# DEVIATION REQUEST AND DECISION FORM

Project Name : Eagleview Subdivision  
 Schedule No.(s) : 5226000001), 5226000001)  
 Legal Description : N2NW4 EX WLY 620.0 FT SEC 26-12-65,S2NW4 EX WLY 620.0 FT SEC 26-12-65

**DEVIATION No. 3** - A deviation from the standards of or in Sections **2.3.2 and 2.2.4.A.5** of the Engineering Criteria Manual (ECM) is requested. Please refer to **deviation exhibit 1**. Also attached is **deviation exhibit 2**, which is referenced in the “explanation of the proposed alternative” section below.

Exhibit 1

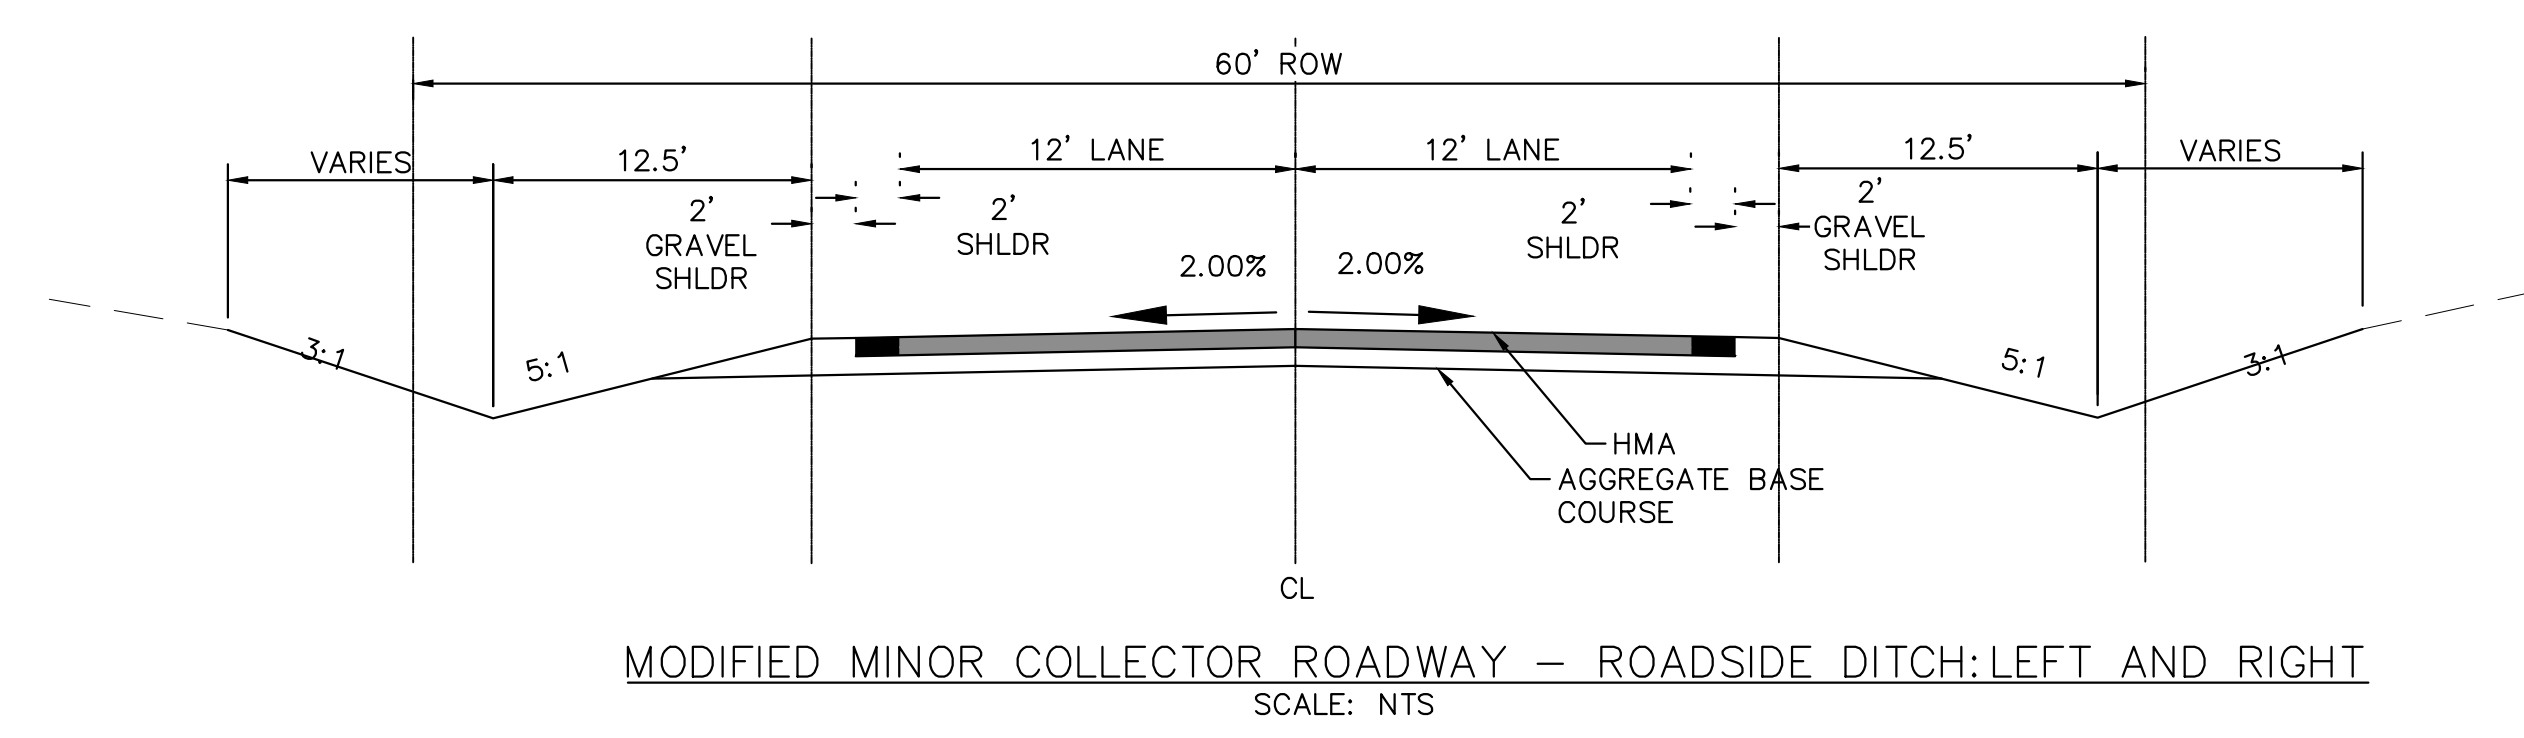
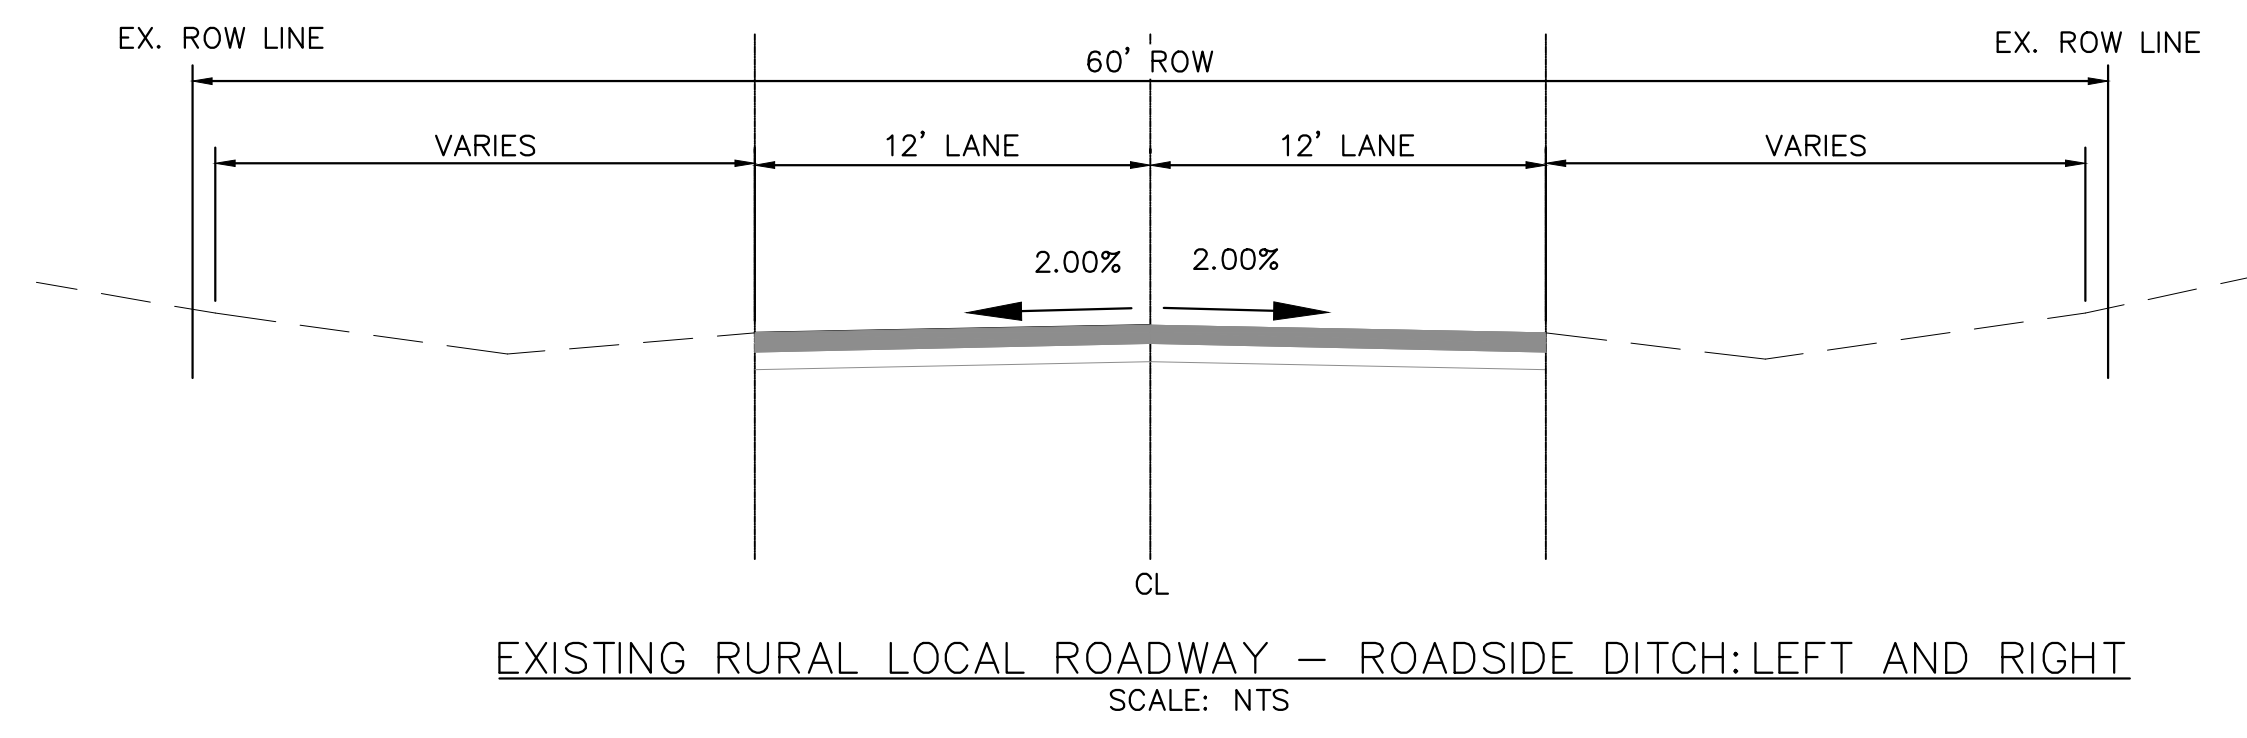
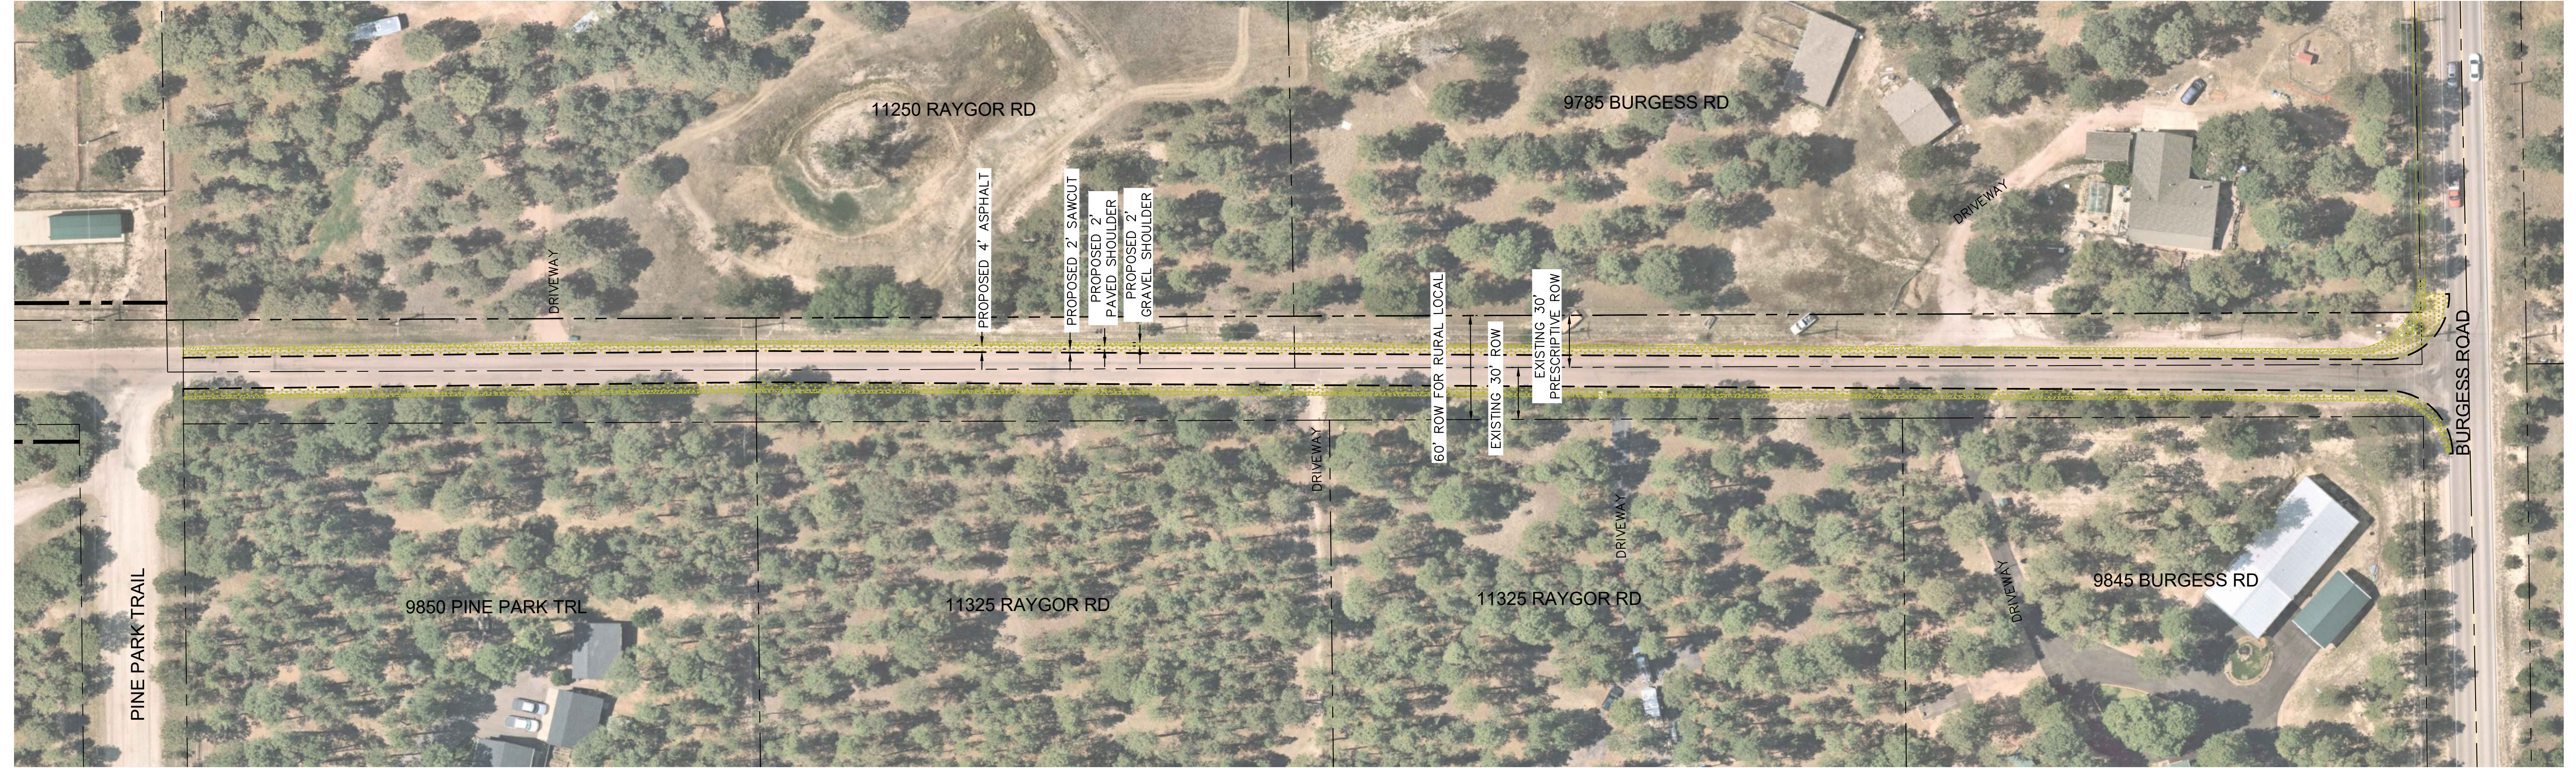
The ADT at the **north end** of Raygor Road is likely within the range of a Rural Minor Collector, currently, even prior to the additional trips estimated for this subdivision. The current Raygor Road ROW and cross section do not meet the ECM standard for a rural minor collector, therefore a deviation is required.

Section of Raygor for which Deviation #3 is requested

This request has been determined to have met the criteria for approval. A deviation from Section 2.3.2, 2.2.4 A5 of the ECM is hereby granted based on the justification provided.

## Deviation Exhibit 2

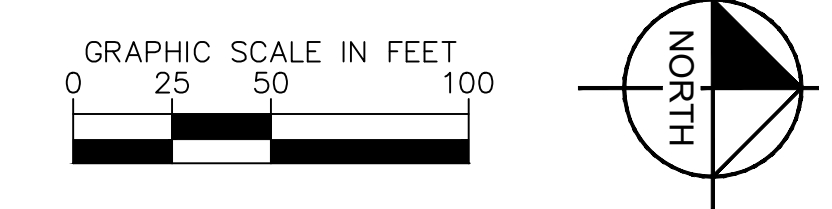
The proposed alternative is to provide an 18-percent fair share of the cost to upgrade Raygor Road to a 28-foot wide paved standard including two-foot paved outside shoulders plus two-foot gravel shoulders. Instead of paying an escrow for the 18 percent of the cost of this improvement, the applicant proposes to complete the improvement on the north end of Raygor between Pine Park Trail and Burgess. **Please refer to deviation exhibit 2**. This is the segment with the highest volume and this construction of a portion in lieu of escrow would put the improved road in-place for the highest volume portion rather than having the funds sit in escrow. The right of way is generally 60-feet. By comparison, the ECM standard Rural Minor Collector cross section has 80-feet of right of way with a 32-foot paved width and 2-foot gravel shoulders (plus roadside ditch sections). The ECM standard pavement section is 3 inches of asphalt over 6 inches of base.

As the current Raygor Road ROW is 60 feet, the Minor Collector cross section would not fit within the existing ROW. The applicant does not control the properties adjacent to Raygor Road. The proposed upgrade to Raygor Road is described above in the “explanation of the proposed alternative” section and depicted in **deviation exhibit 2**.

Asphalt widening to mill and overlay a minimum of 12 inches of existing asphalt from the sawcut line. Street construction plans submitted with the final plat application to finalize the extent of mill and overlay.
